TECHNICAL EVALUATION REPORT

MASONRY WALL DESIGN

PEACH BOTTOM ATOMIC POWER STATION UNITS 2 AND 3

September 12, 1984

SKETCHES OF WALL MODIFICATIONS

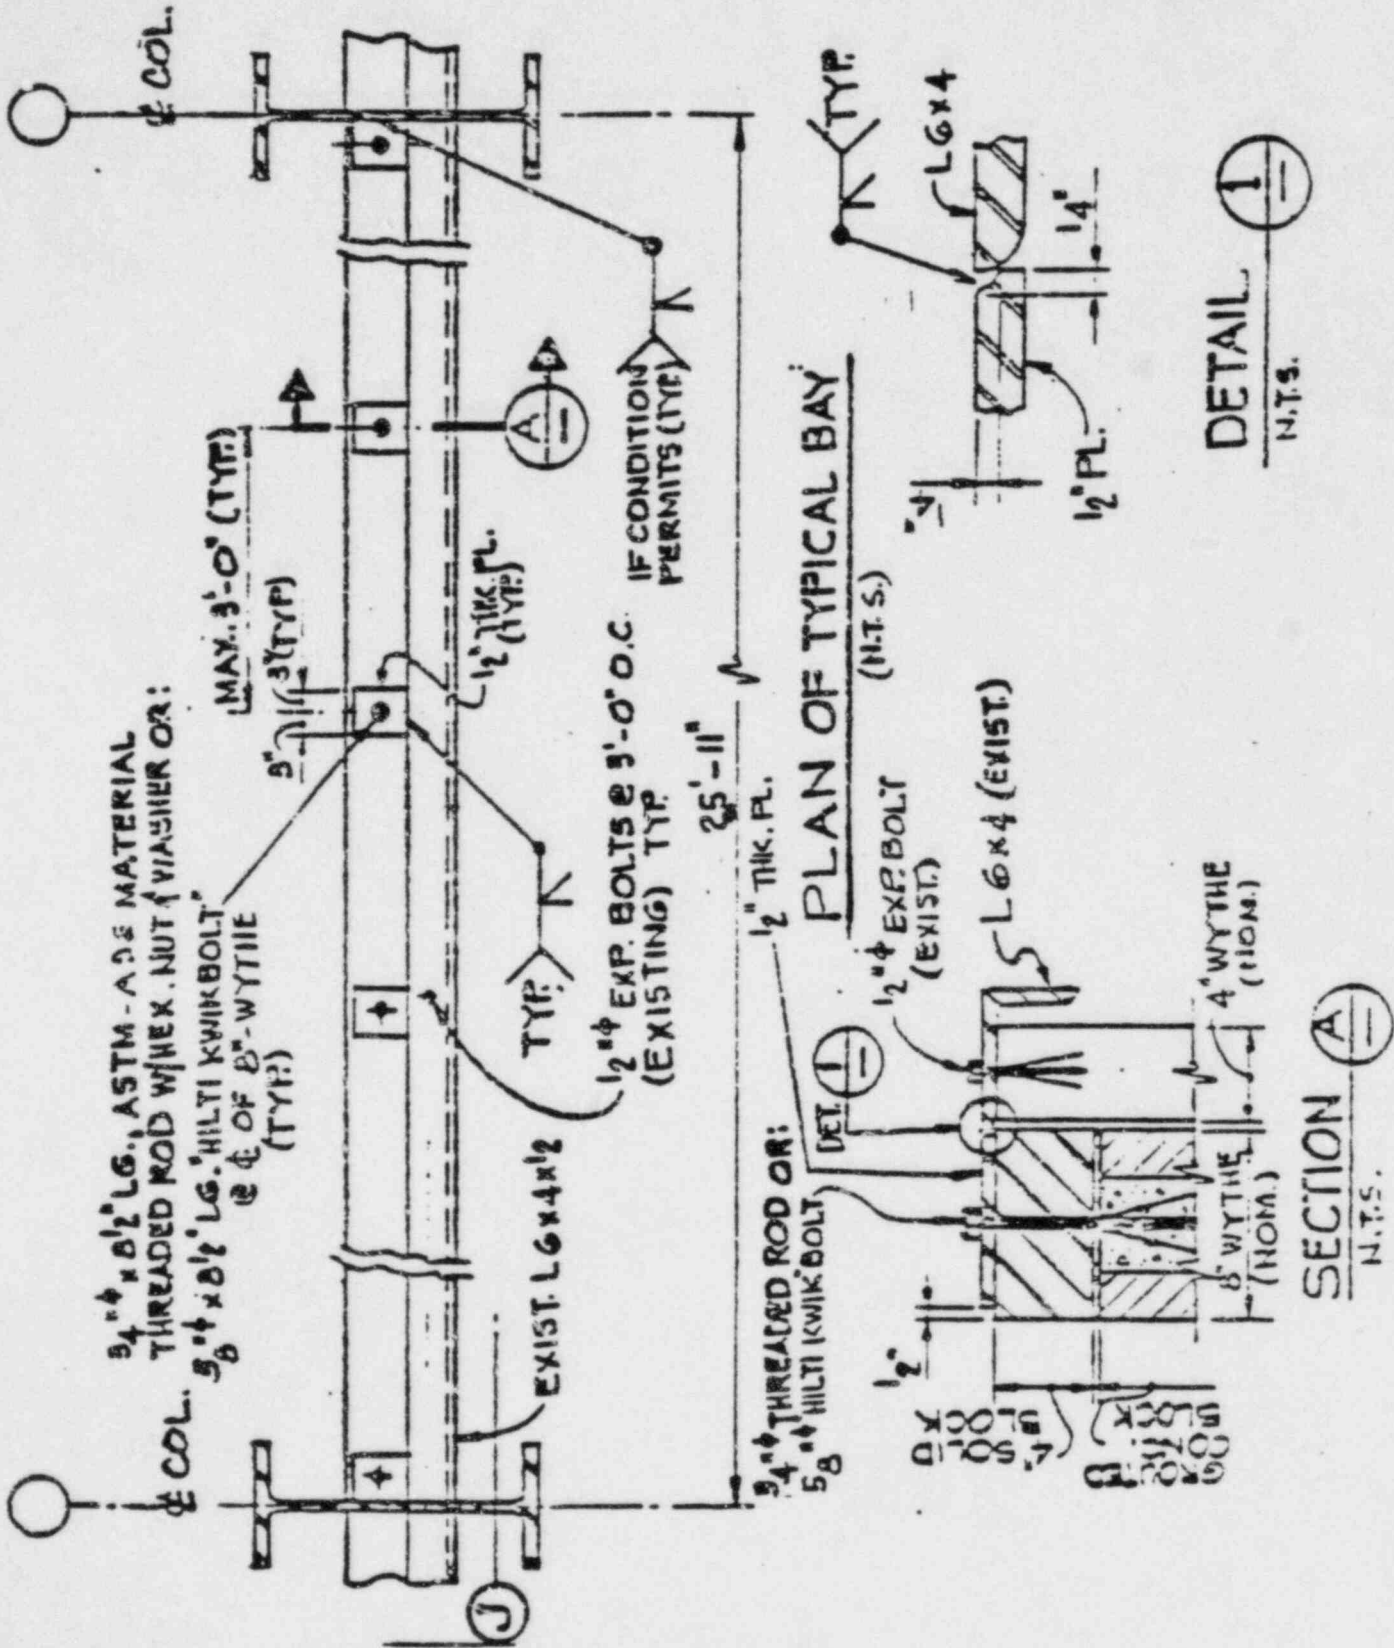
Provide details of proposed wall modifications and indicate, using sample calculations, how these modifications will correct the wall deficiencies.

According to the Licensee response, the wall modification improves the support condition at the top of the wall by connecting the two wythes. Before wall modification, mechanical connection of the top 6 X 4 angle was only to a 4-in wythe through 1/2-in diameter expansion bolts. A 1/2-in plate has been welded to the top angle and anchored to the 8-in wythe with 5/8-in diameter expansion bolts. The details of the wall modifications are given in Appendix B.

The Licensee indicated that the purpose of the modifications to these walls was to improve support conditions at the top of the walls by connecting the two wythes. This was accomplished by welding small 1/2-in plates at regular intervals to the existing restraint (a 6 x 4 angle), which was already bolted to the top of one wythe. The new plates were then bolted to the top of the second wythe, thus connecting the wythes. Refer to Appendix B for sketches of a typical modification.
